UPGRADE PLANS TO ADDRESS SEP TOPIC II-1.C,
OFFSITE HAZARDS AND TMI ACTION PLAN
ITEM III D.3.4, CONTROL ROOM
HABITABILITY

SAN ONOFRE UNIT 1

SOUTHERN CALIFORNIA EDISON COMPANY

January, 1986

FIGURE 1
CONTROL ROOM HVAC SYSTEM SCHEMATIC DIAGRAM

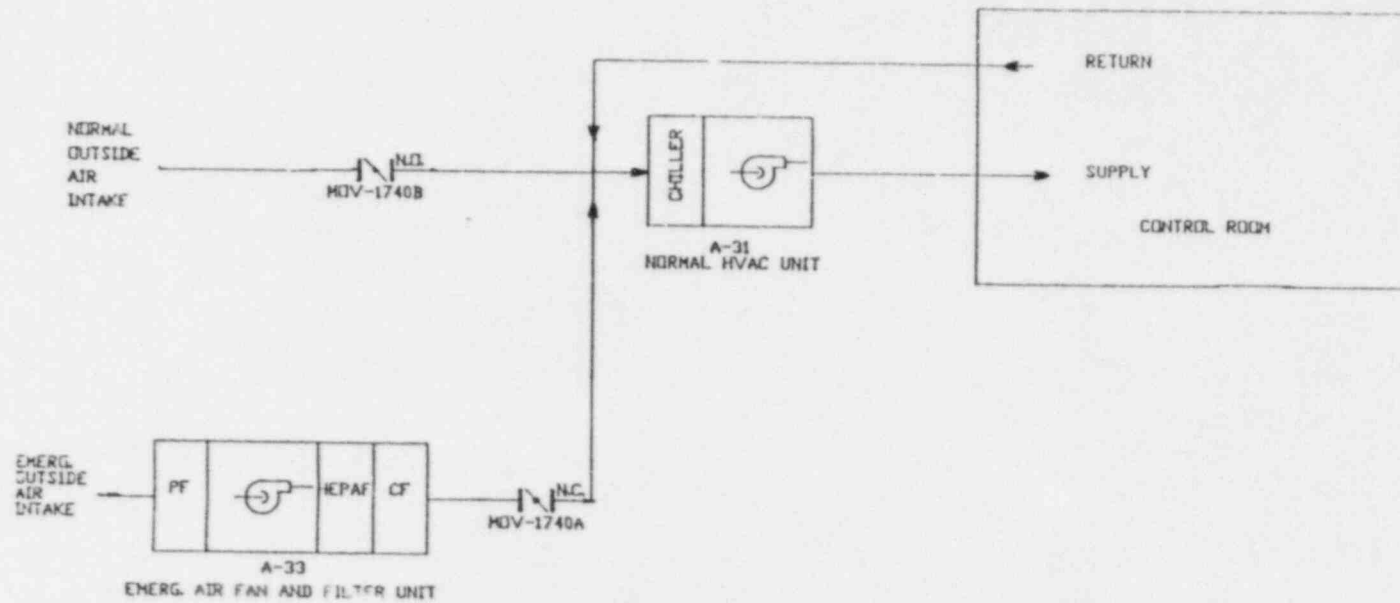
- o Installation of redundant leak tight dampers in the normal and emergency fresh air intake ducts of the control room and TSC systems.
- o Modify the control room HVAC control logic to allow a manually actuated, isolated recirculation mode of operation.

- o Increasing the TSC HVAC capacity to handle the cooling loads from both the TSC and the adjacent control room, and installation of cross-connecting ducting between the TSC and control room HVAC systems to permit use of the TSC HVAC to cool the control room and TSC in the event of a loss of the control room HVAC system. This system will not be seismic or tornado qualified except where it interfaces with the primary control room HVAC system. The existing control room and TSC HVAC systems are as shown in Figures 1 and 2, respectively.

FIGURE 2
TECHNICAL SUPPORT CENTER HVAC SCHEMATIC DIAGRAM

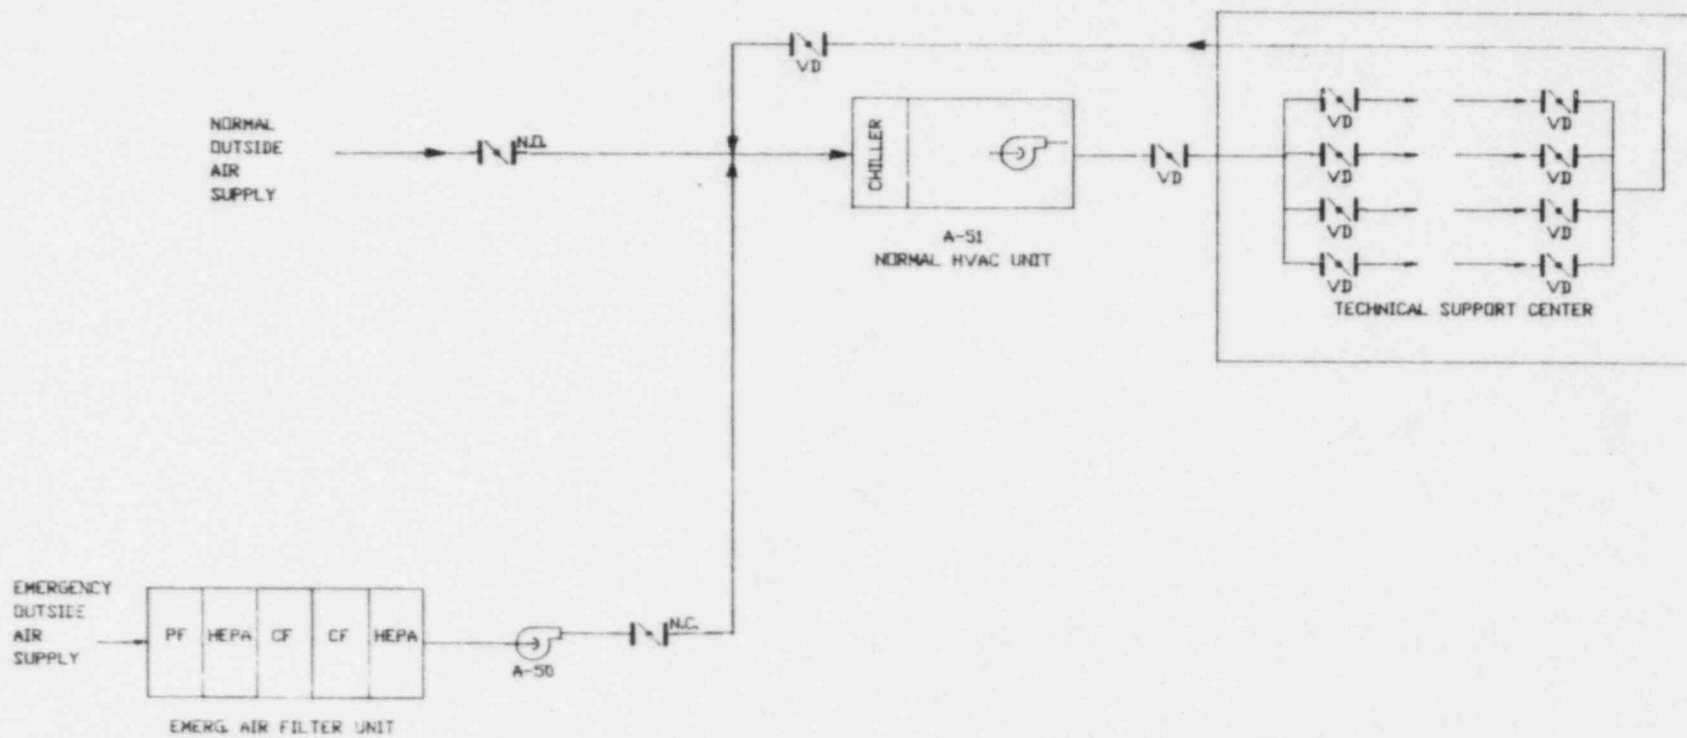
The upgrade of the TSC HVAC capacity and addition of cross-connecting capability between the control room and TSC provides a fully capable backup of active components to the control room HVAC using the TSC HVAC system. The basis for the upgrade is to address a single active failure in the control room HVAC system. The TSC HVAC system does not meet all the requirements of the Standard Review Plan Section 6.4 for a redundant HVAC system. However, the upgrade does address the infrequent loss of the control room HVAC and the subsequent need for cooling.
